**COUNTY OF SAN MATEO
PLANNING AND BUILDING DEPARTMENT**

SUBJECT: EXECUTIVE SUMMARY: Continuation of the consideration of a Coastal Development Permit to install and restore a low-profile landscape planter to an existing gas station located at 9400 Cabrillo Highway in the unincorporated Moss Beach area of San Mateo County. The project is appealable to the California Coastal Commission.

County File Number: PLN 2017-00199 (Stefanick/KN Properties)

**SITE PLAN
PLANTER CONSTRUCTION**

Proposed Curb Planter Detail Section 3 feet wide, 6 inches high

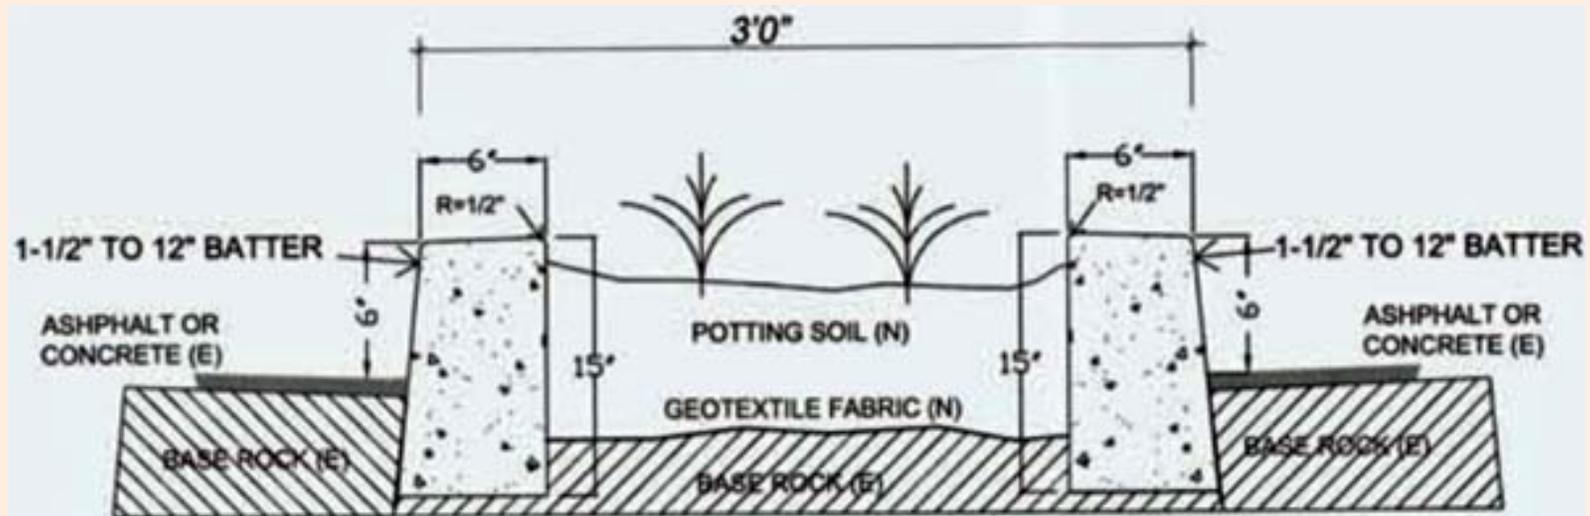
MCC requests planter extension to Vermont, minimum 4-ft planter width, and reduced highway access from 144 to 60 ft.

3 x 34 ft planter proposed to replace 13x63 ft planter removed w/o permits.

Curb (6" HxW) occupies one third of planter width.

No matter how drought tolerant, plant viability will be poor in this extremely limited soil volume.
